ADDENDUM NO. 5

14-AUG-24

PHASE III FACILITY CONVERSION AT NEW GLOUCESTER STATE FISH HATCHERY

BGS PROJECT NO.: 3289-312

SHEET
03D-102

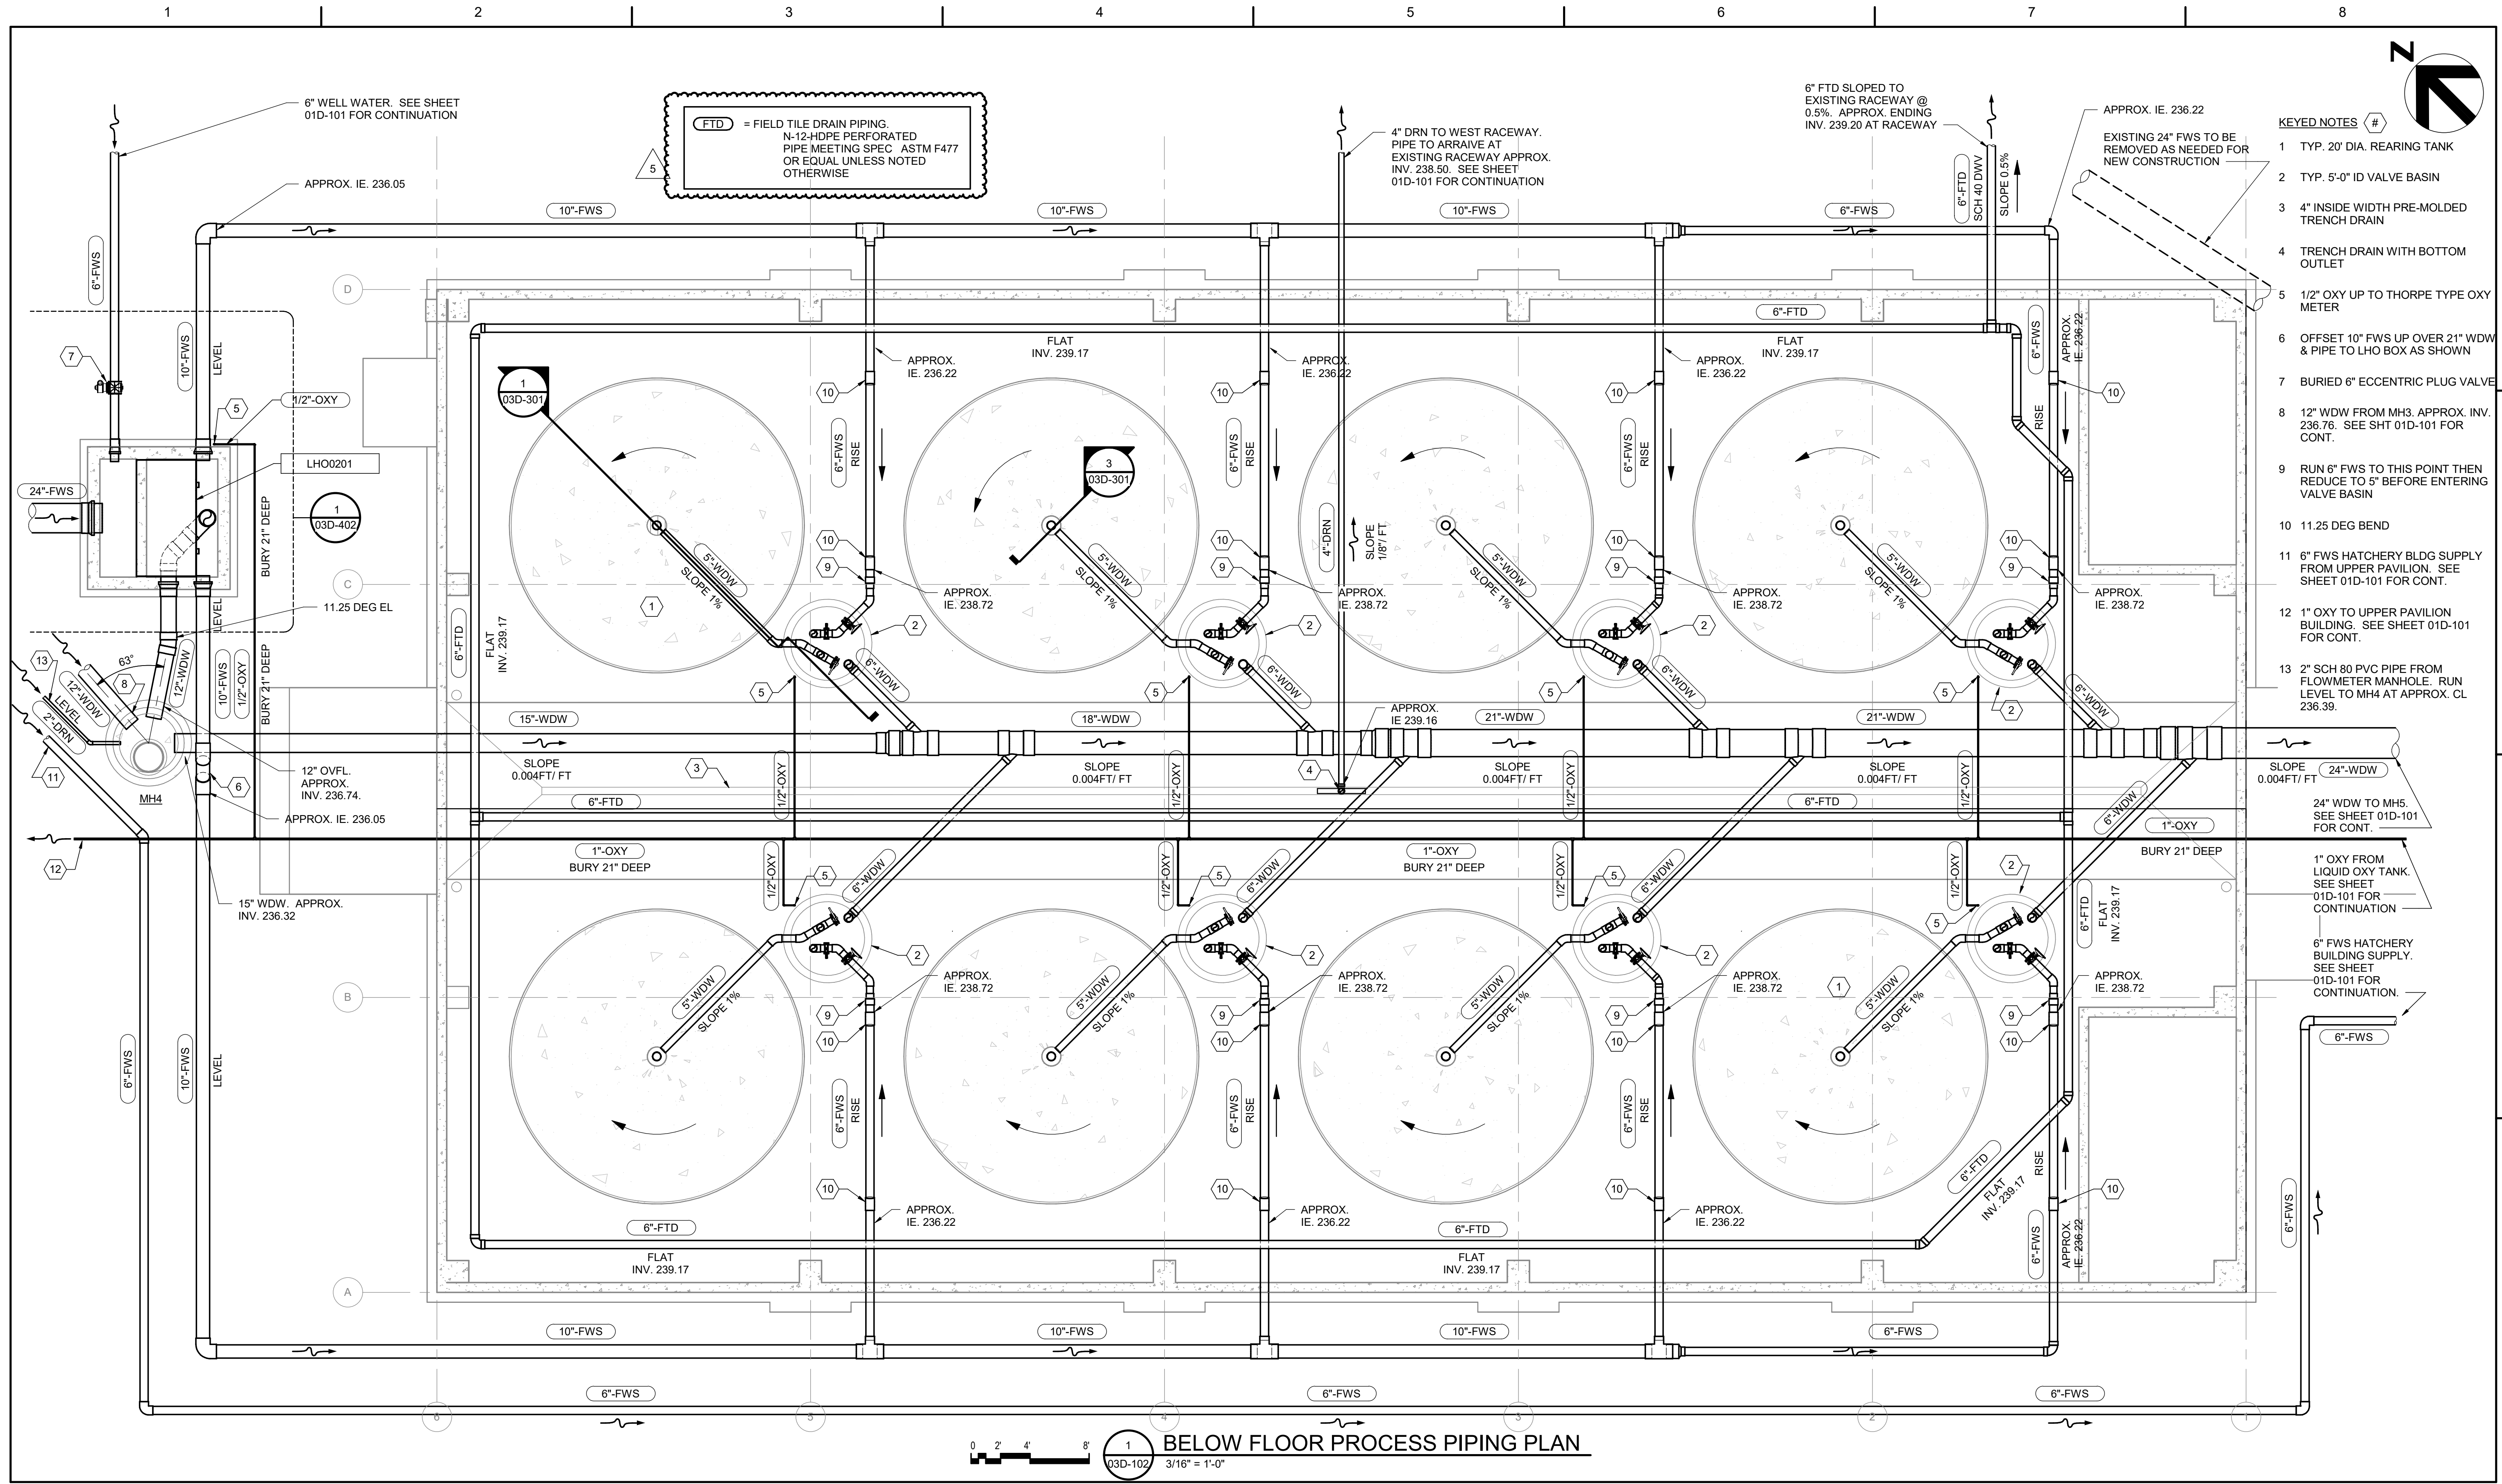
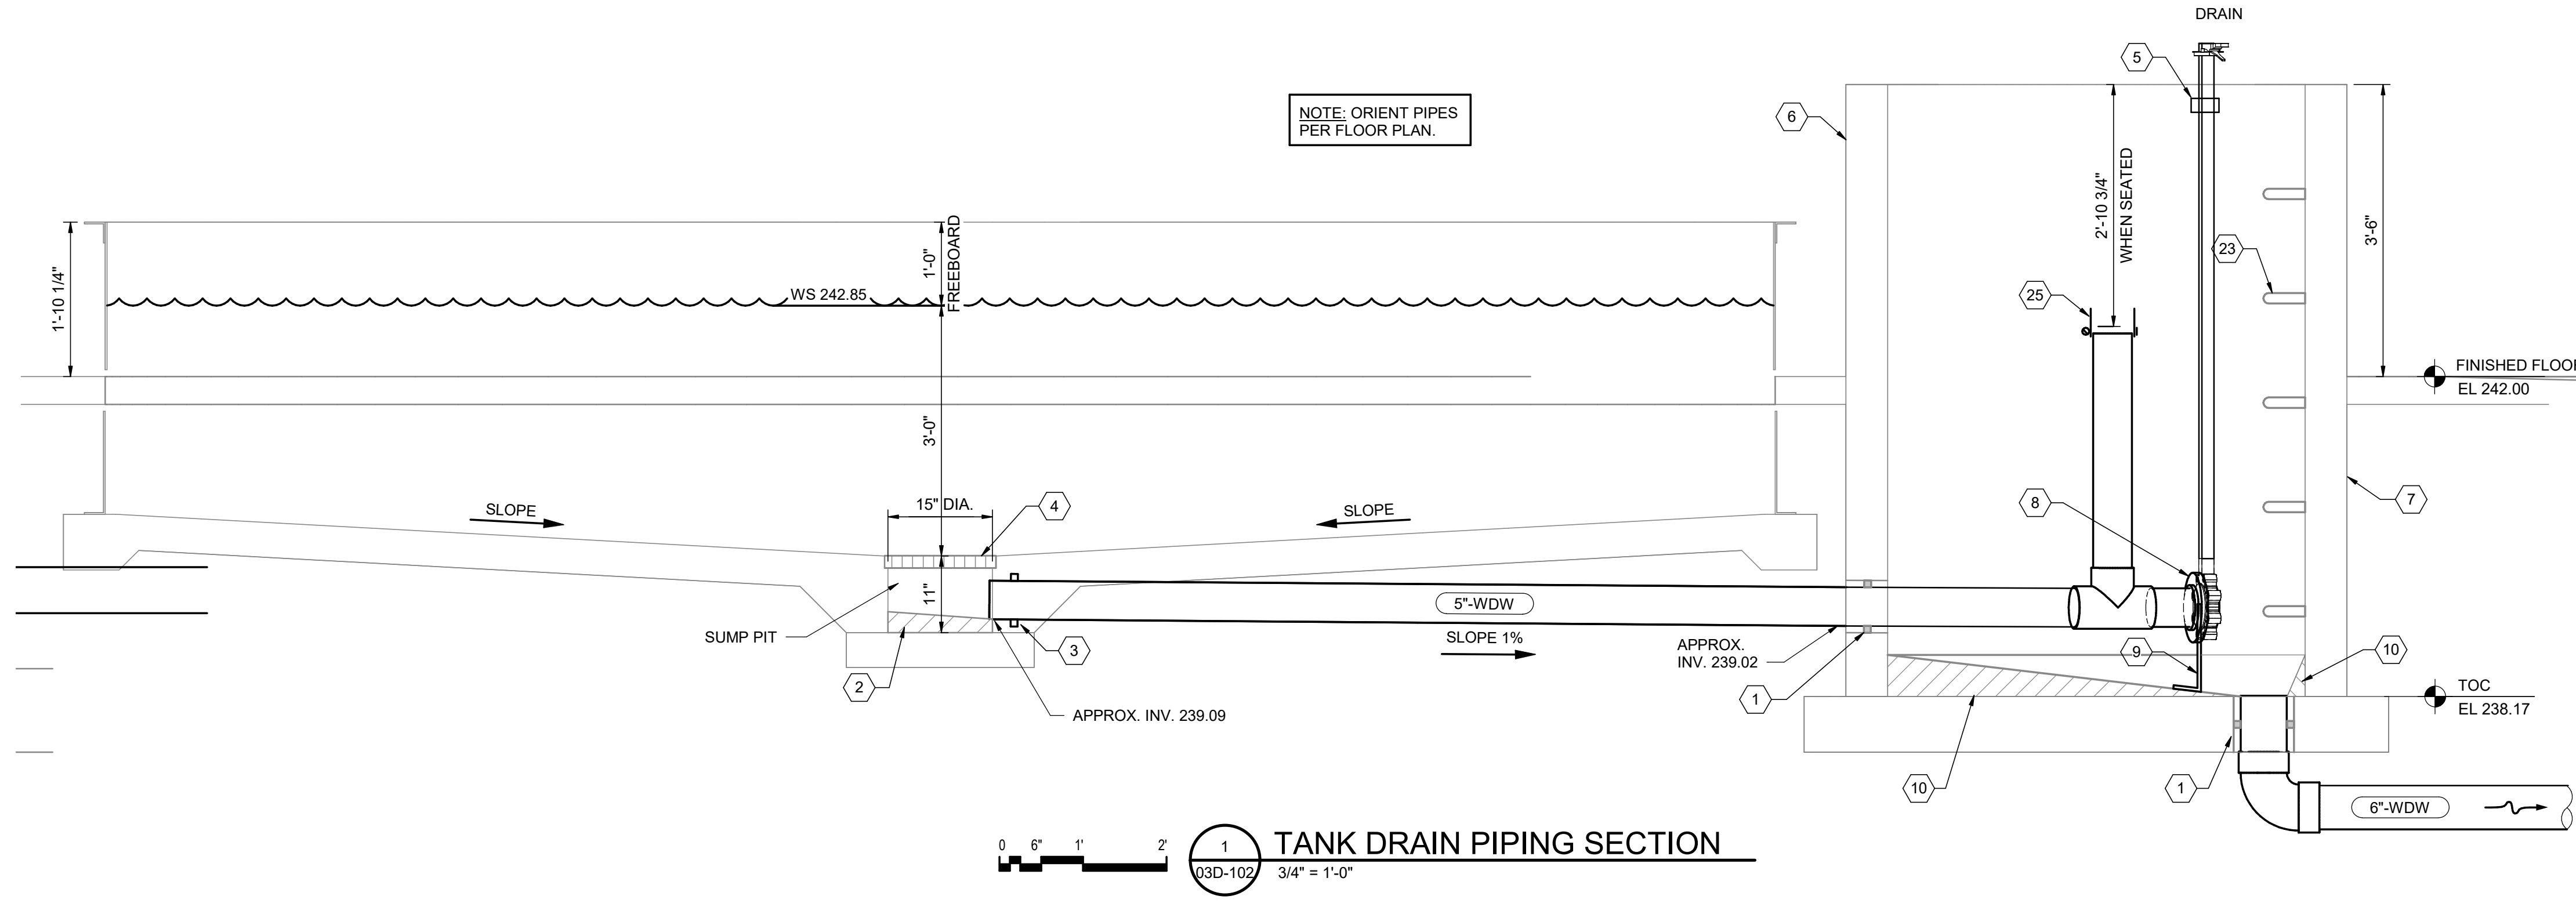
- a. **REPLACE SHEET:** Added 6”-FTD (FIELD TILE DRAIN)

FTD = FIELD TILE DRAIN PIPING.
 N-12-HDPE PERFORATED
 PIPE MEETING SPEC ASTM F477
 OR EQUAL UNLESS NOTED
 OTHERWISE

SHEET
03D-301

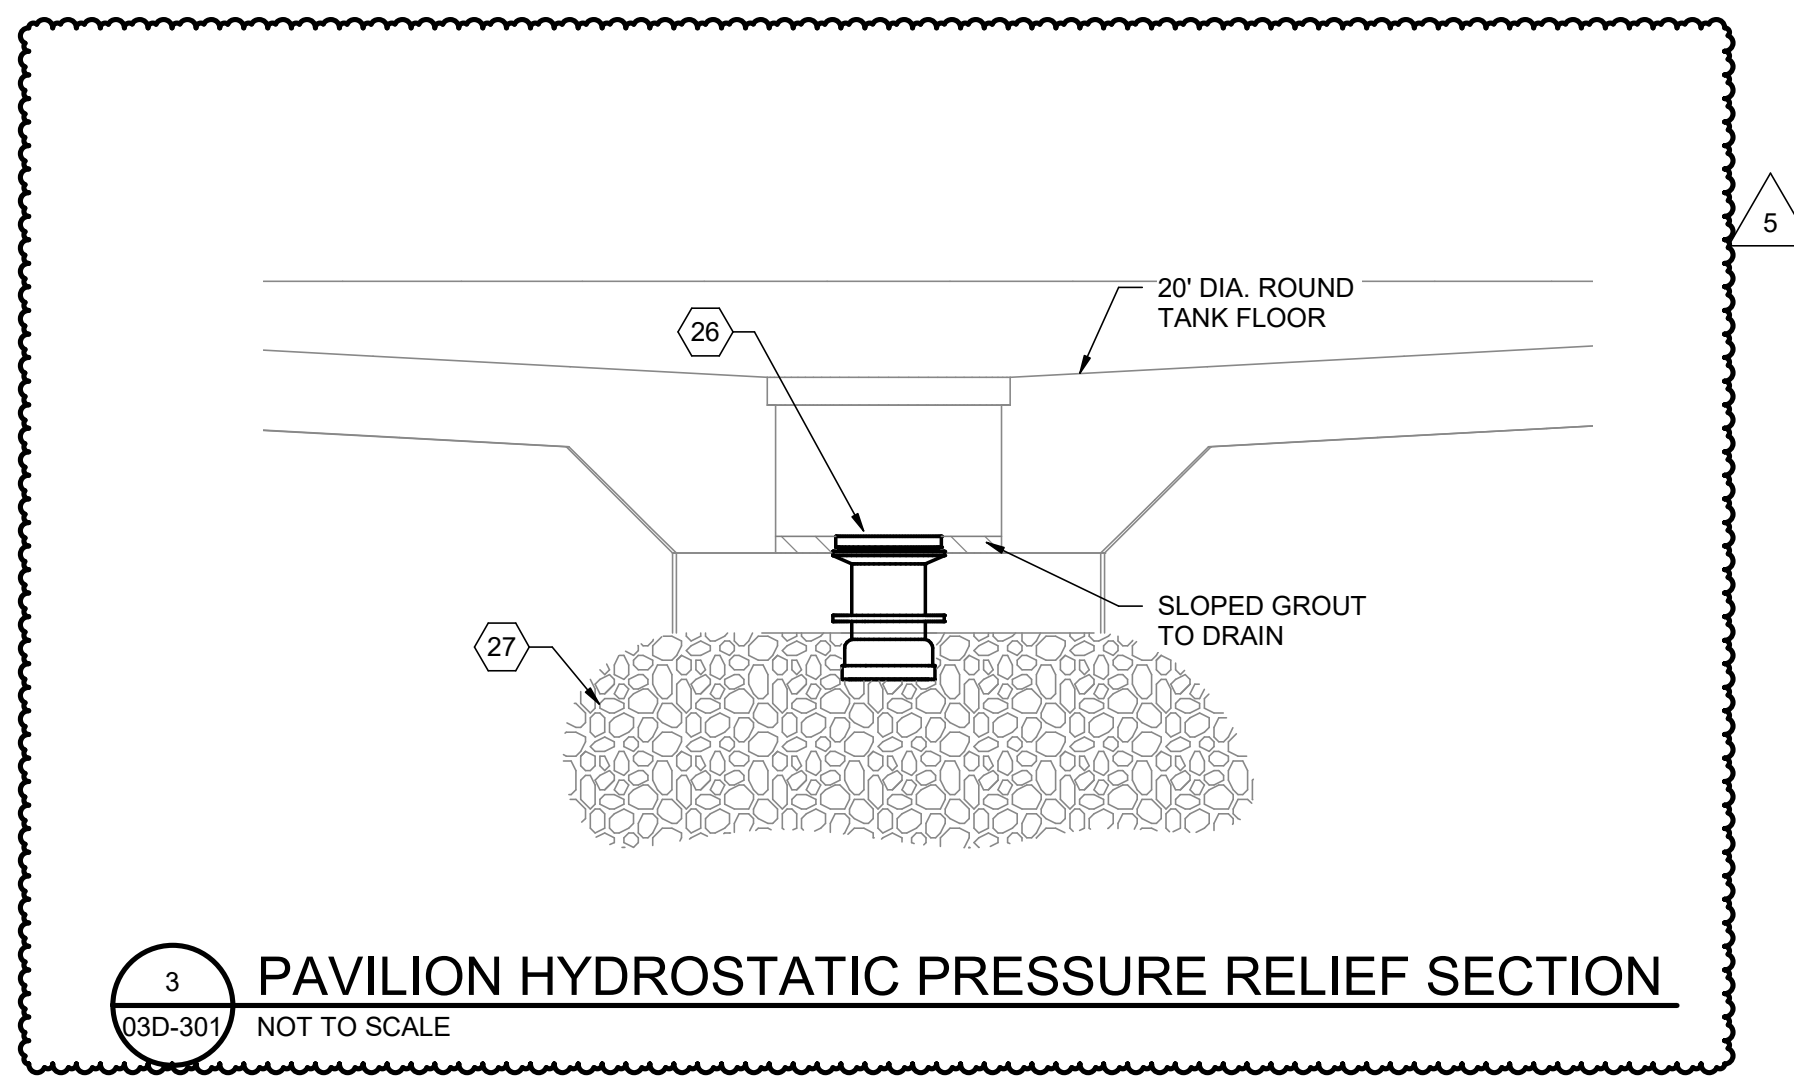
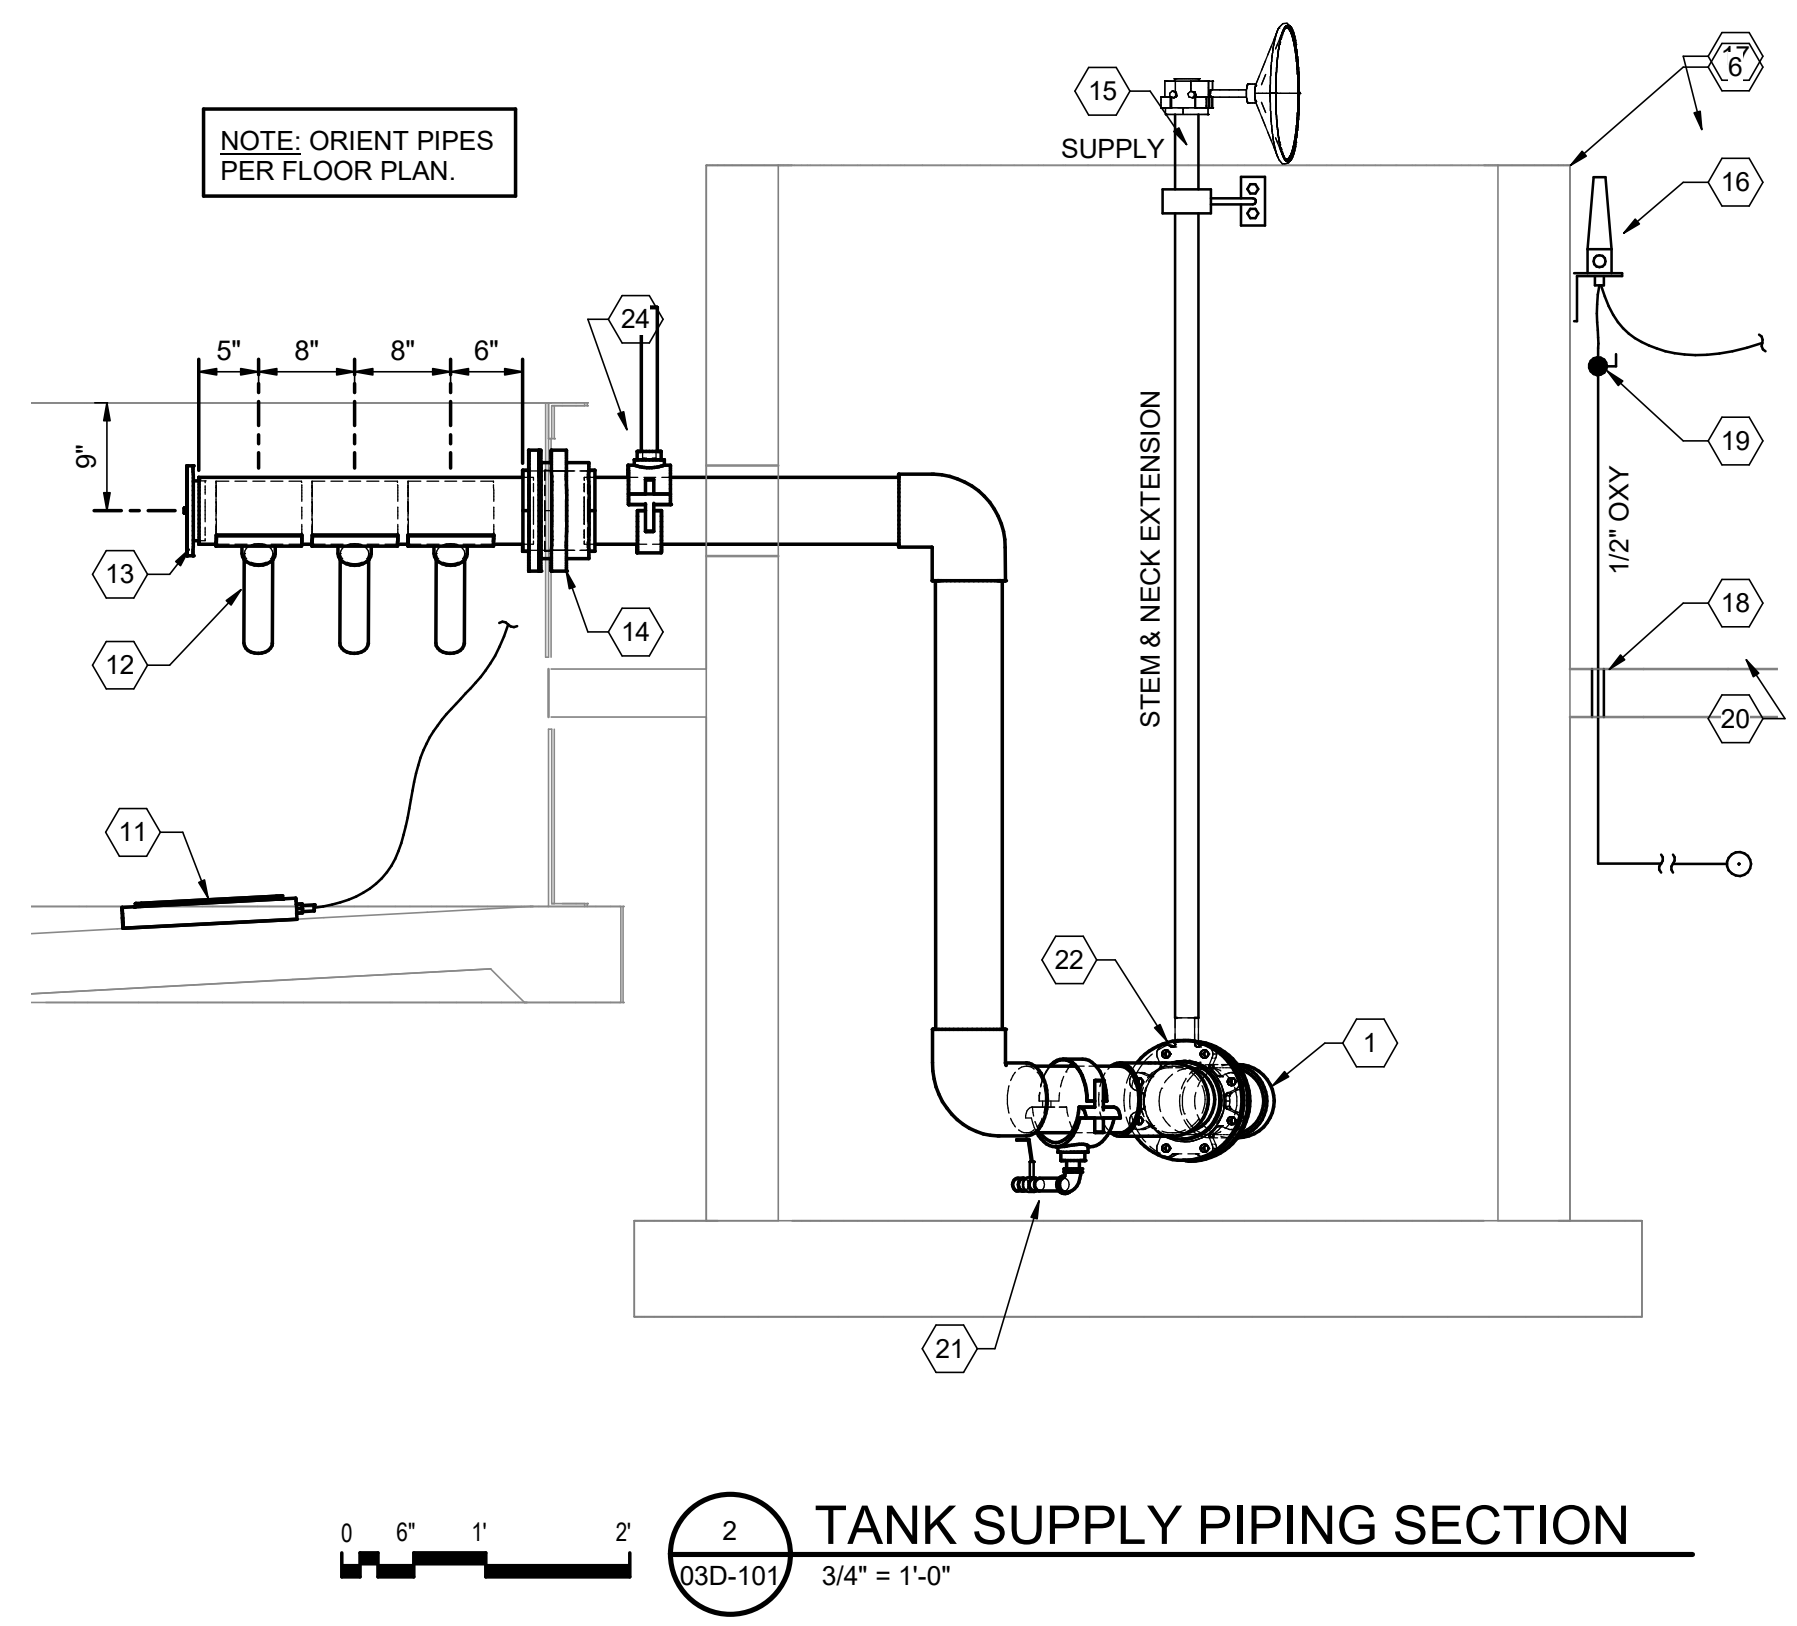
- a. **CHANGE: DETAIL 3**

- 25 ELASTOMERIC COUPLING
 - 26 4" FLOOR MOUNTED HYDROSTATIC PRESSURE RELIEF VALVE EQUAL TO PENN-TROY A2550RSN/4
 - 27 MINIMUM 2'-6"x2'-6"x2'-6" CLEAN CRUSHED STONE WRAPPED IN GEOTEXTILE FABRIC CENTERED ON PRESSURE RELIEF VALVE PIPE
